Subject: HEADER WEATHERSTRIP - BUTYL ADHESIVE ISSUES	Bulletin No: 09-001/06
	Last Issued: 1/26/2006

2006 MX-5

Butyl Adhesive Oozing From Header Weather-Strip

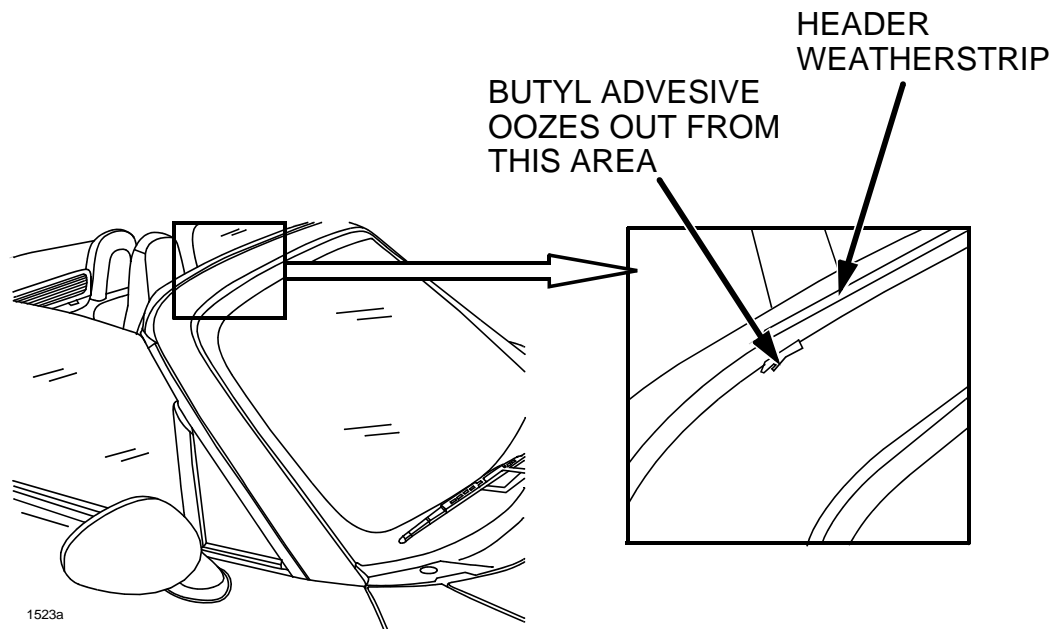
- The butyl adhesive securing the header weather-strip to the body above the windshield oozes out onto the paint on vehicles with VINs lower than JM1NC*****101795 built prior to July 14, 2005..
- Excessive gaps between the header weather-strip and the body above the windshield on vehicles with VINs lower than JM1NC*****100708 built prior to July 1, 2005.

As the convertible top is used, the header weather-strip gets compacted. This causes excess butyl adhesive to be pushed out of the header weather-strip and onto the painted surface. As a production change, the process of butyl adhesive application has been modified during assembly.

A mass production change of the butyl adhesive application process has been implemented on vehicles with VINs higher than JM1NC*****101795 built after July 14, 2005.

Customers having this concern should have their vehicle repaired using REPAIR PROCEDURE A - BUTYL ADHESIVE OOZING FROM HEADER WEATHER-STRIP.

Gap Between Header Weather-Strip And Body

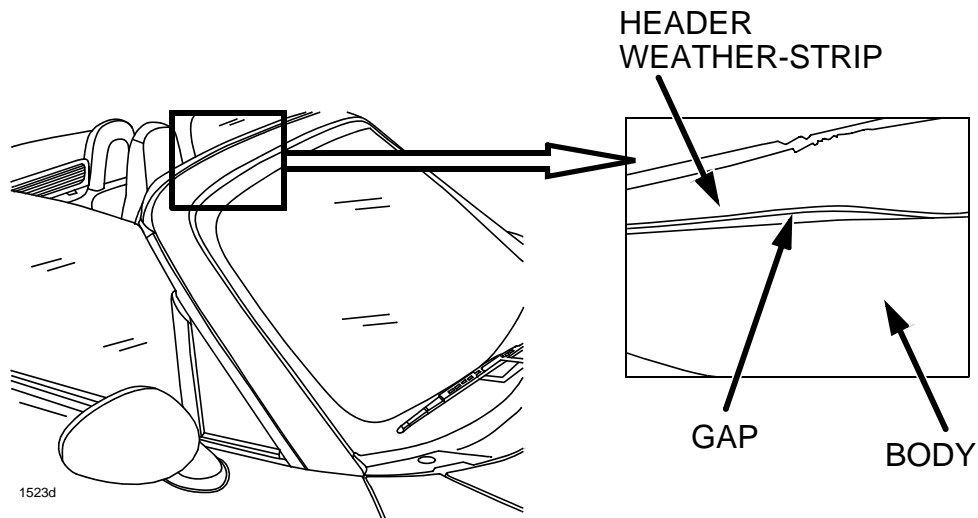
On some vehicles, the waterproofing butyl adhesive inside the header weather-strip is unevenly applied. As a production change, the process of butyl adhesive application has been modified, and a pad has been added inside the header weather-strip to prevent this condition.

A mass production change of the butyl adhesive application process has been implemented and a pad has been added inside the header weather-strip on vehicles with VINs higher than JM1NC*****100708 built after July 1, 2005.

Customers having this concern should have their vehicle repaired using REPAIR PROCEDURE B - GAP BETWEEN HEADER WEATHER-STRIP AND BODY.
